An ordinance approving and authorizing the execution of Change Order No. 1 for the Montz Pump Station No. 1 (Project No. P210301), to increase the contract amount by \$111,702.07.

CHANGE ORDER

No. 01

Contract: Montz Pump Station No. 1

ETCC 2055		Schneider Electric
Project: Montz Pump Station Location: New Orleans, LA Contract: 51276520		Rev: Base Fault: Phase

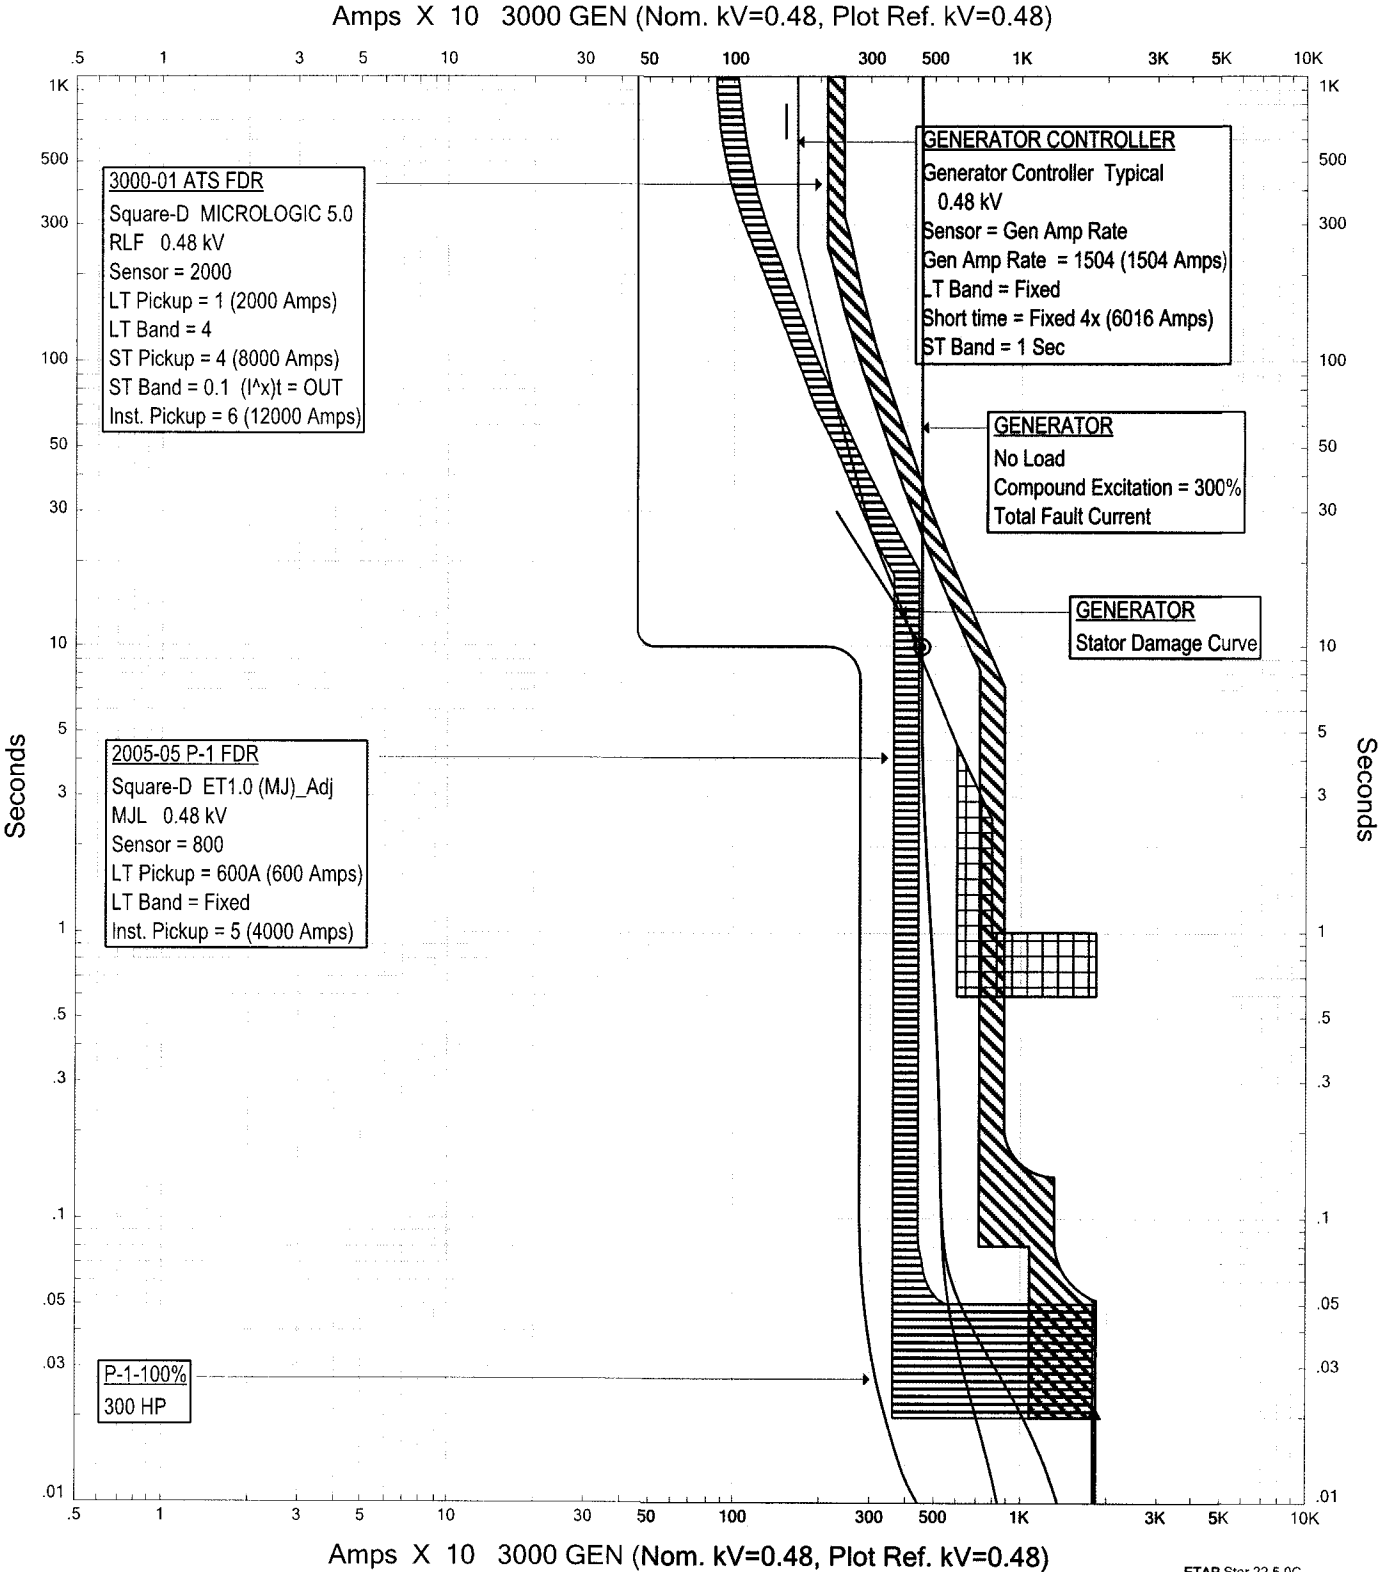
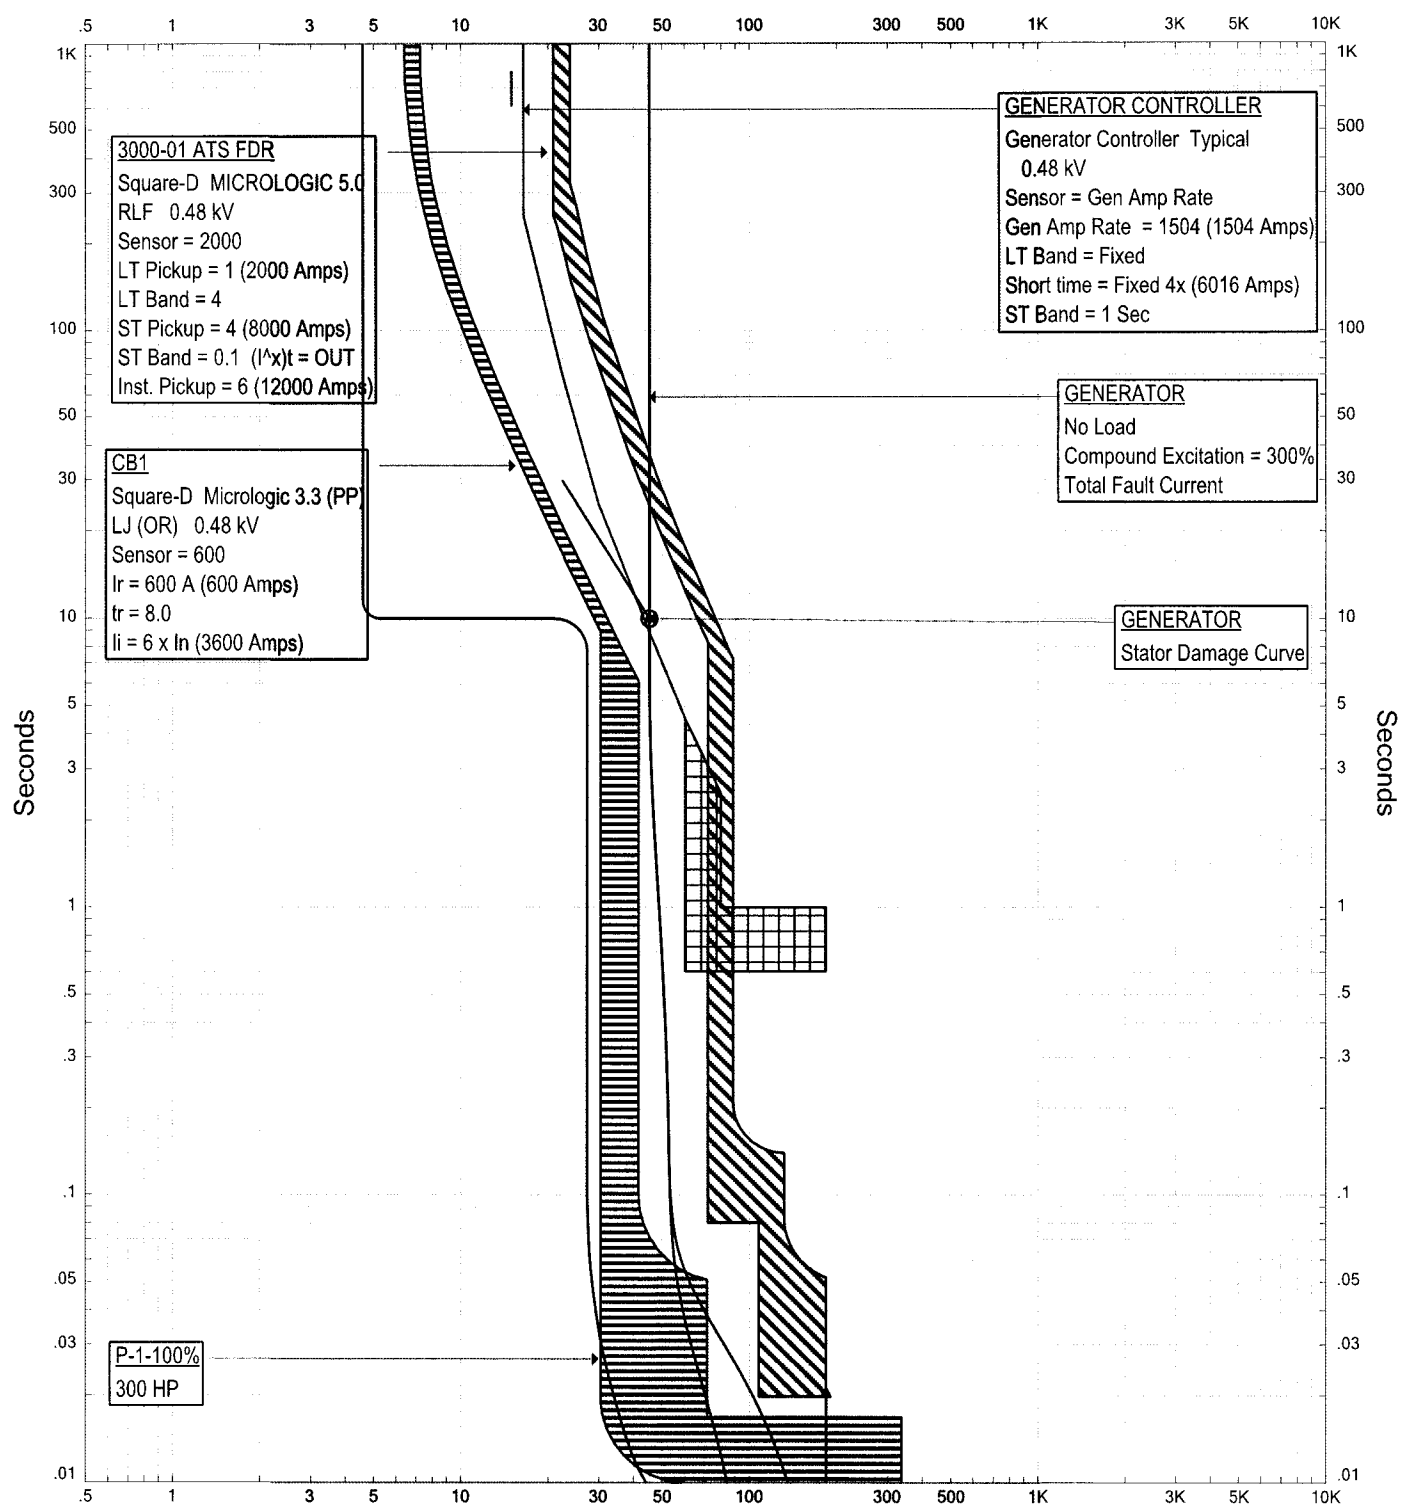
Revise the four (4) pump soft starter breakers from M-frame to L-frame breakers to add the adjustable time delay function necessary for proper coordination with the main generator breaker. The generator breaker is outside of SqD's scope and therefore coordination could not be confirmed prior to the bid.

The initial coordination study included M-frame breakers that meet the MCC specification (see below & attached), but the revised study requires additional functionality beyond what was specified to achieve proper coordination.

Our MCC for this project was quoted with “soft starts” that included our “standard” UL rated thermal-magnetic M-frame MCCB. Due to coordination study factors that were out of Schneider Electric’s control, The study findings requested we change the “standard” UL rated M-frame soft start breaker to a “LJ” electronic trip “LI” breaker to meet the current coordination study needs. We contacted our plant to verify if the “LJ” breaker would still comply with the UL rating of the soft start, which they verified it would. This change of breaker request has resulted in our change order #4. Please let me know if you have any other questions or concerns.

Sealevel Construction is pleased to submit, for your consideration, a lump sum proposal in the amount of **\$13,859.31** to revise the four (4) pump soft starter breakers from M-frame to L-frame breakers to add the adjustable time delay function necessary for proper coordination with the main generator breaker.
